Product Change Notice (PCN)

PCN Number: **PCN-0456171R-01**

Product(s) Affected: **PJ-031DH**

PREVIOUS CUI DEVICES DETAIL / IMAGE	NEW CUI DEVICES DETAIL / IMAGE

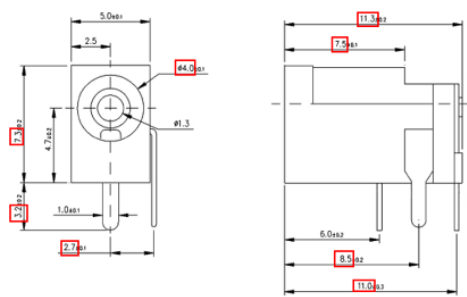
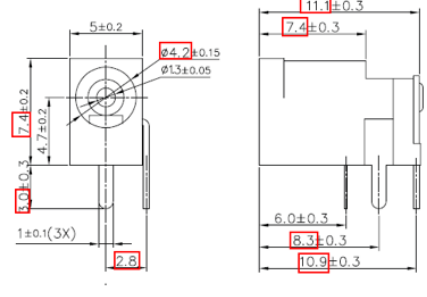
Description of Change: **Product re-engineered for improved manufacturability and production yield. See image below for product changes. Cosmetic differences may be visible and not affect the form fit and function of the product.**

<p>Recommended PCB Layout Top View</p>	 <p>Recommended PCB Layout Top View</p>

PREVIOUS CUI DEVICES DETAIL / IMAGE			NEW CUI DEVICES DETAIL / IMAGE		
DESCRIPTION	MATERIAL	PLATING/COLOR	DESCRIPTION	MATERIAL	PLATING/COLOR
center pin	brass	silver	center pin	brass	CuSn
terminal 1	brass t=0.50	silver	terminal 1	brass t=0.40	silver
terminal 2	MM alloy t=0.20	silver	terminal 2	stainless steel t=0.20	silver
terminal 3	brass t=0.50	silver	terminal 3	brass t=0.40	silver
housing	PA10T (UL94V-0)	black	housing	PA10T (UL94V-0)	black

<p>MATING PLUG Jack Insertion Depth: 7.0 mm</p>	 <p>MATING PLUG Jack Insertion Depth: 6.2 mm</p>
---	--
